**SUBJECT:** **CONDITIONAL USE / CLASS 3 SITE PLAN REVIEW CASE NO. CU-SPR23-01**  
**1290-1292 12<sup>th</sup> STREET SE – 97302**  
**AMANDA NO. 22-124807-PLN**

Summary: Conversion of an existing building to a marijuana production use.

Cannabis Growing Facility  
1290 12th St. SE, Salem, OR 97302

SITE PLAN  
SCALE: 1/8" = 1' 0"

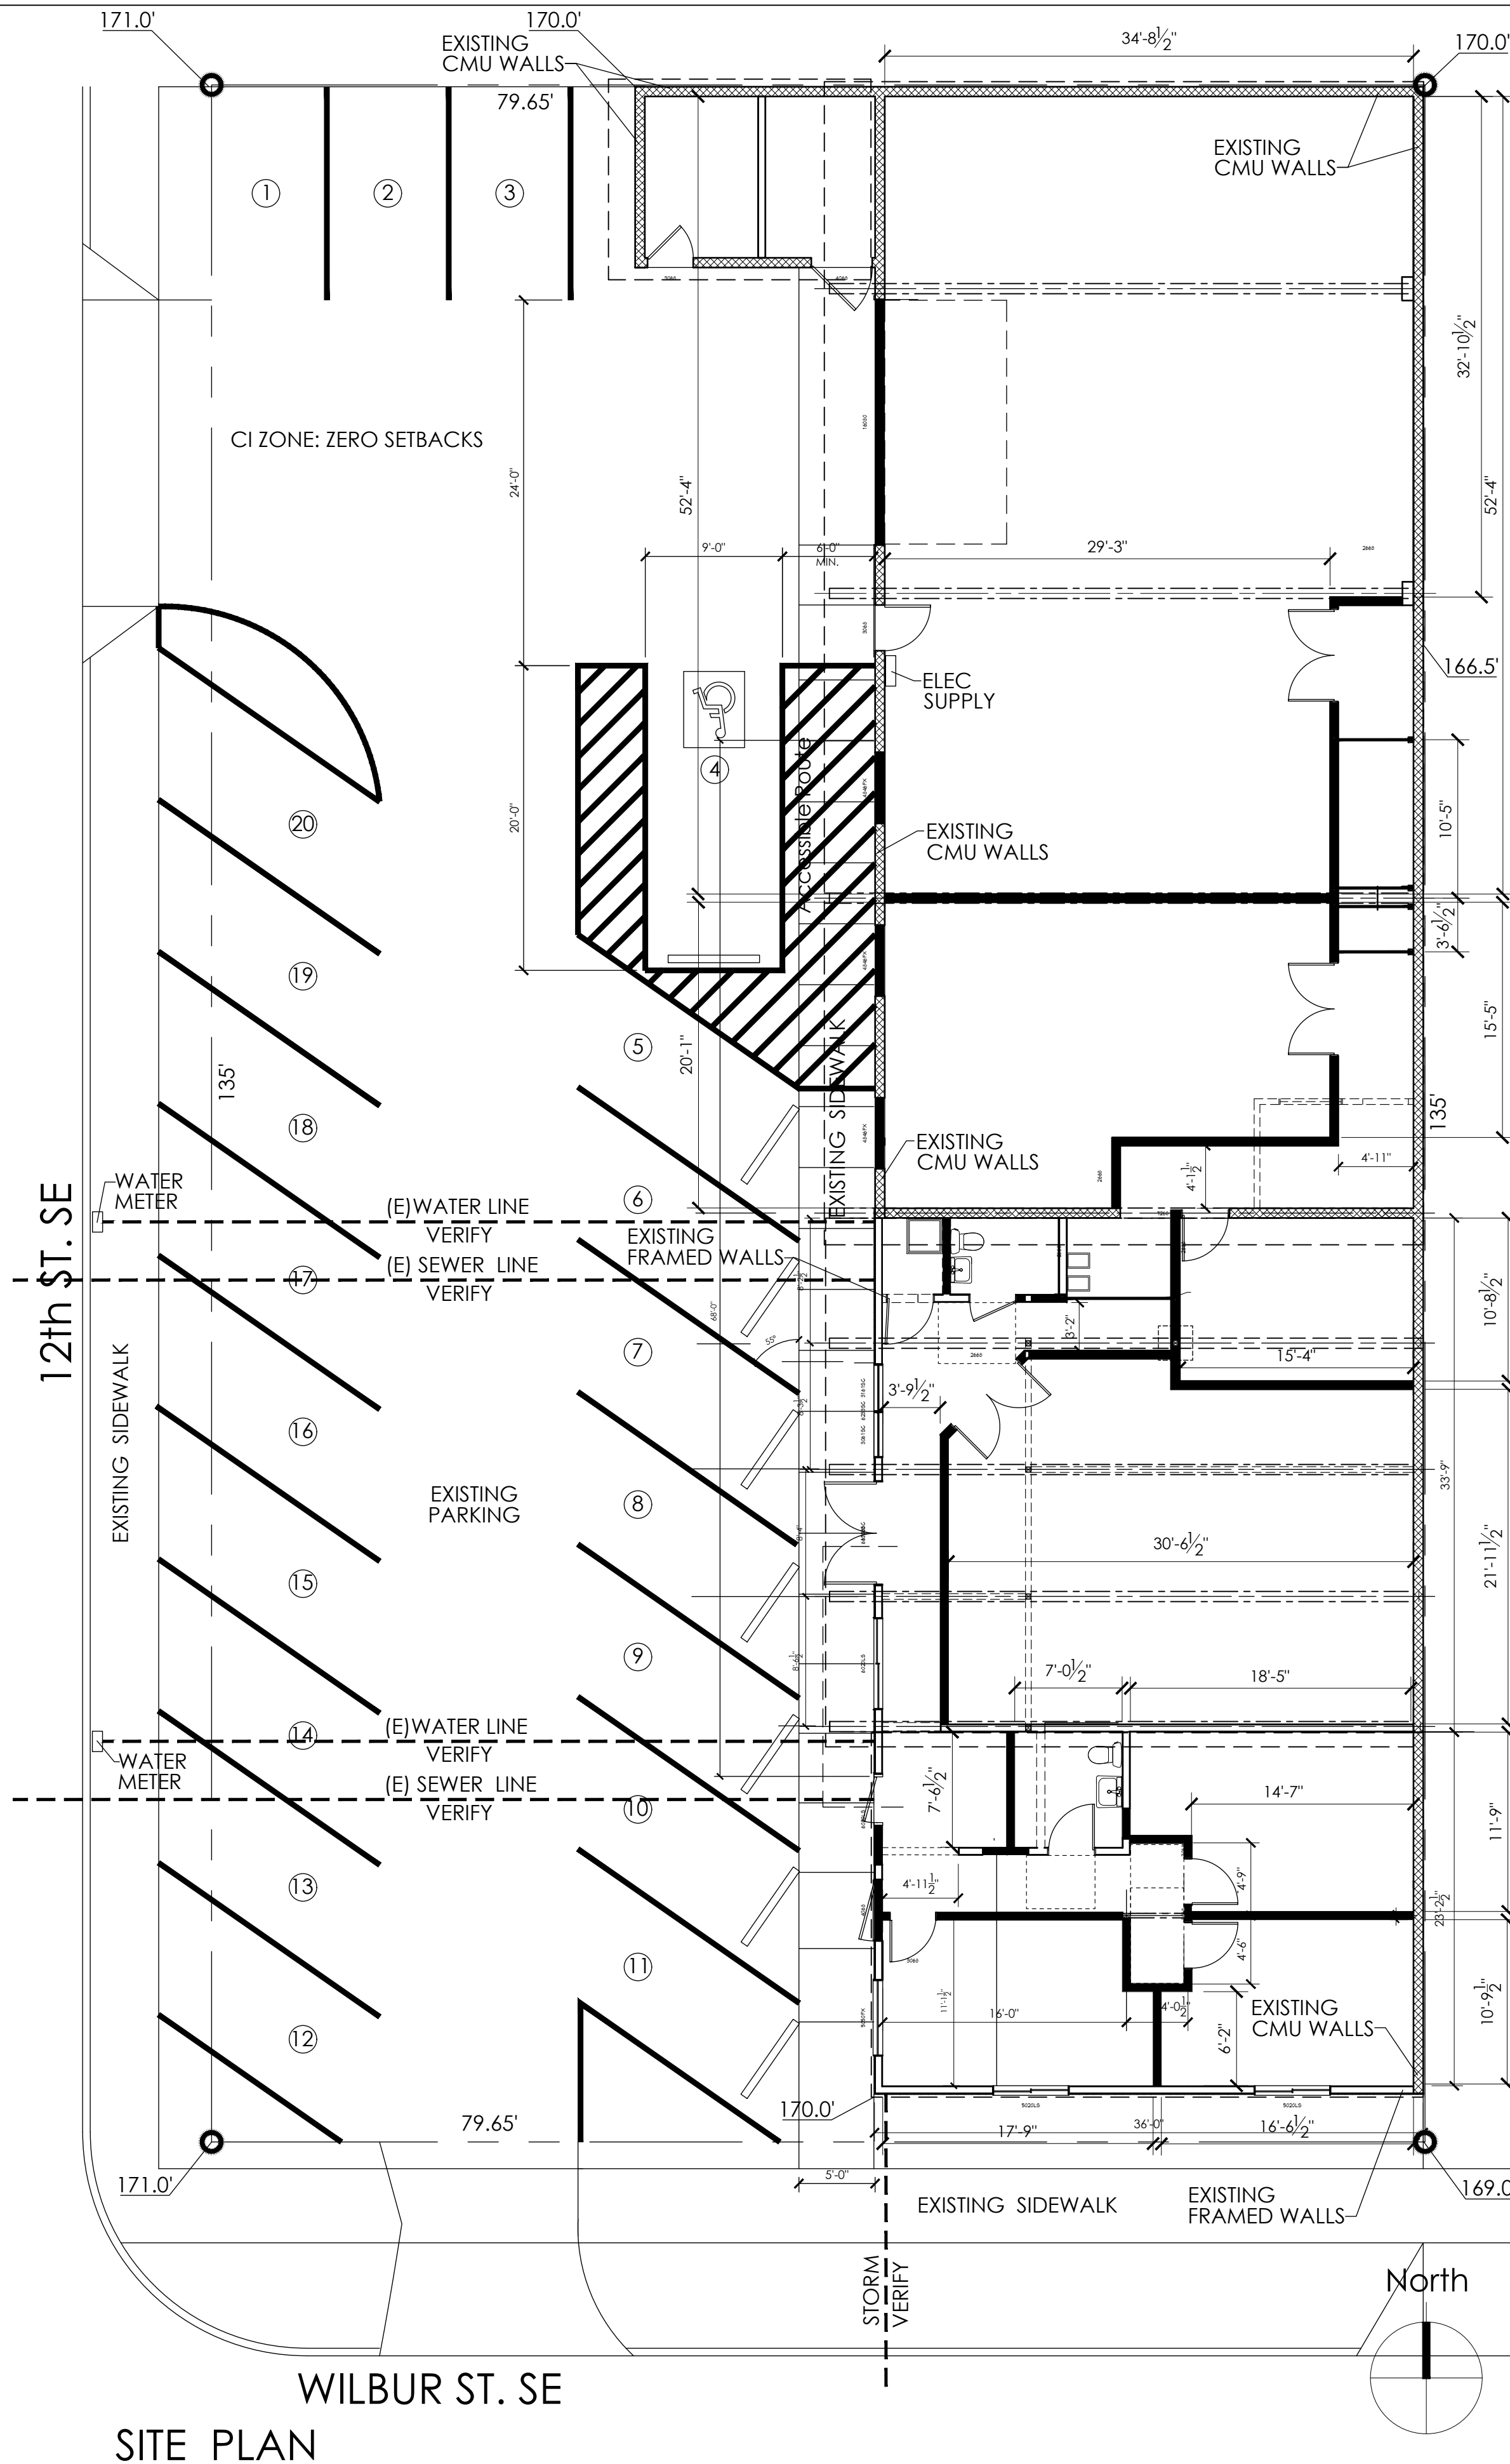
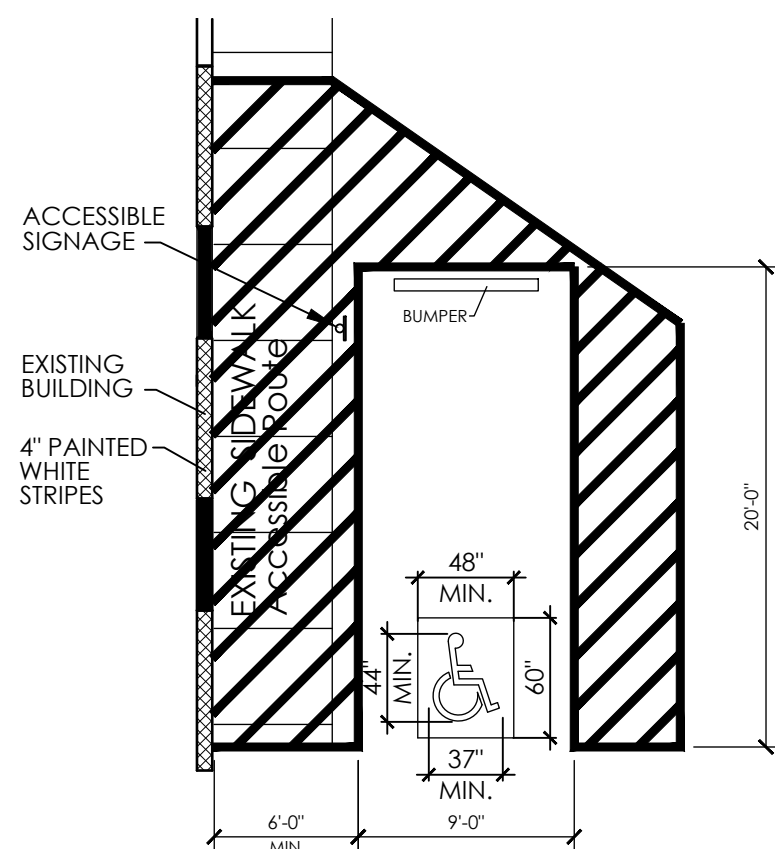
There are existing parking spaces that extend into the public right-of-way of 12<sup>th</sup> Street SE, as shown on the applicant's site plan. There are no barriers or wheel stops that would restrict vehicles from traversing onto the sidewalk, causing a potentially dangerous situation for pedestrians. Staff recommends these parking spaces be removed, or wheel stops be installed on the private property that will prohibit vehicles from entering the pedestrian space.

**Condition 5:** Install wheel stops on the subject property to restrict vehicles from parking within the 12<sup>th</sup> Street right-of-way.

OF  
SHEET NO. 22412  
A1

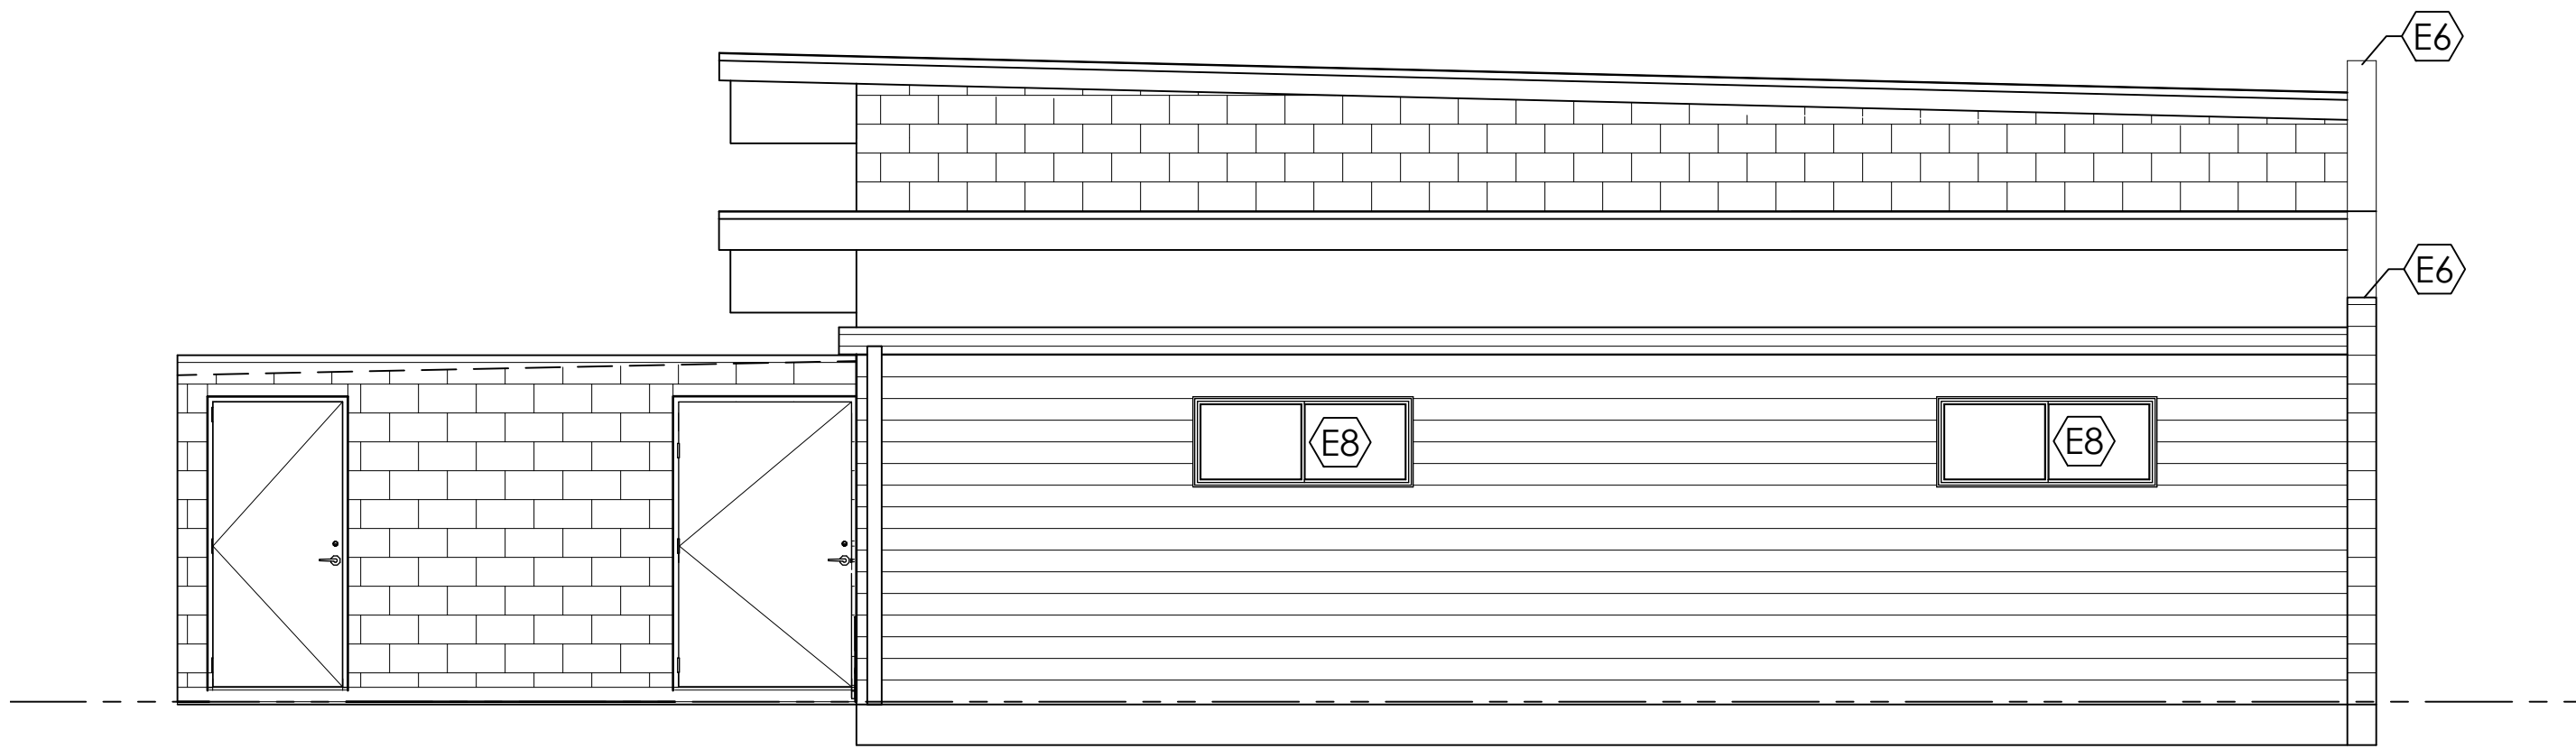
- Existing build fed via overhead 240V open delta service. Based on new mechanical equipment information appearing on sheet A1, the existing electrical service will not have adequate capacity to power the new equipment. A new, higher capacity, electrical service to the building will likely be required.

**Staff Response:** The applicant is required to coordinate with PGE to ensure the power supply to the building is adequate for the new proposed use.
